BOUNDARY, RECOVERY, RETRACEMENT AND MONUMENTATION MAP
VERNAL POOLS WETLAND MITIGATION SITE
JACKSON COUNTY

AFFIDAVIT OF CORRECTION

22655

SEPTEMBER 4, 2018
SCALE: 1" = 200'
SHEET 2 OF 2

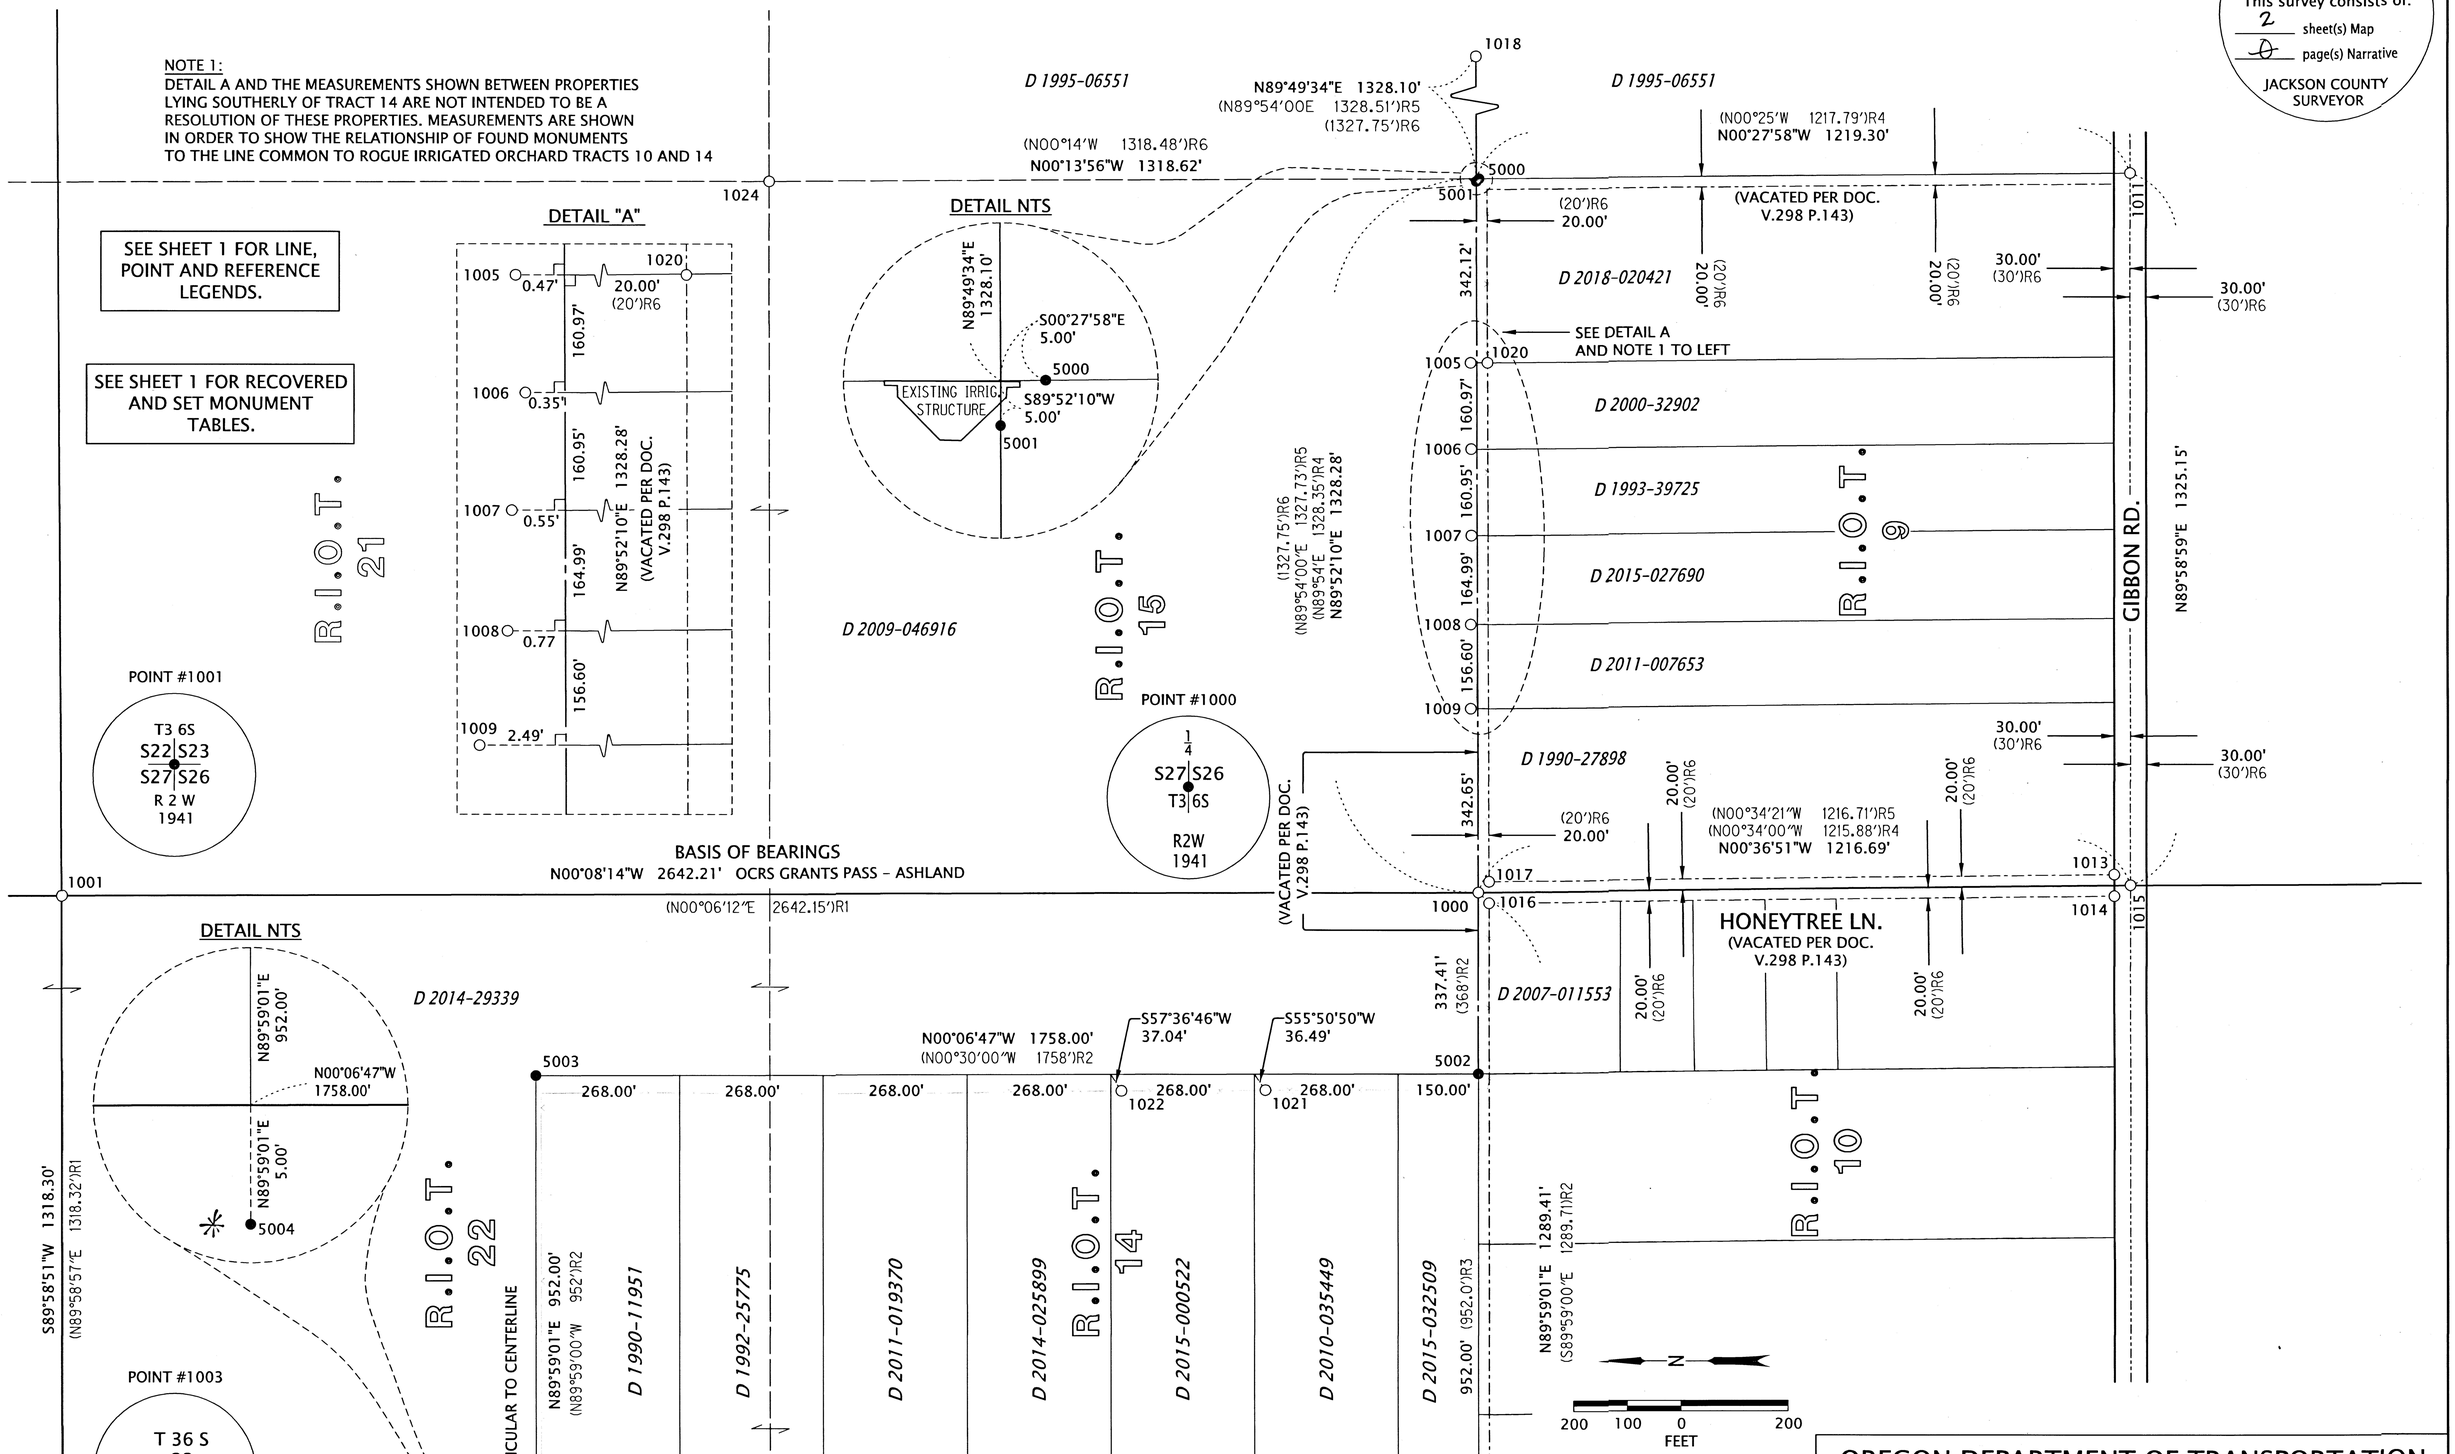
1. On sheet number 2 of 2 on Survey Number 22655, a witness corner was set and labeled as 5004. After construction of a fence was performed along this boundary line, this monument was checked to ensure it had not been disturbed. This search uncovered an iron spindle at the true location of the corner witnessed by point 5004. No record of this monument could be found but it agreed with the resolved location of the established property corner as witnessed by point 5004.
